1 Products affected

2 Type of change

Product Change Notification					PCN DFKH-14 round pins		
owner	creation date	release date	released by	change order no	rev	page	D10-045-928
segatro	26.05.2020	03.02.2021	blumhe	2019984	A	1 of 1

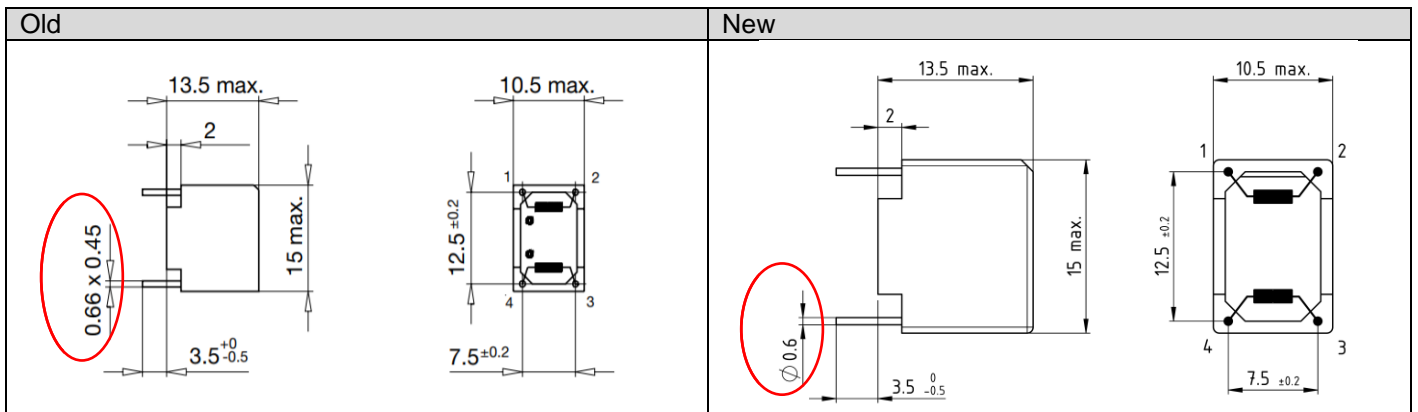
- Terminal pins changed

- Rectangular pins substituted with round pins

- Standardization of choke cases
- Optimize assembly process

Form	No	-
Fit	Yes	Pin diameter and shape
Function	No	-
Manufacturing	No	-
Label	No	-
Packaging	No	-
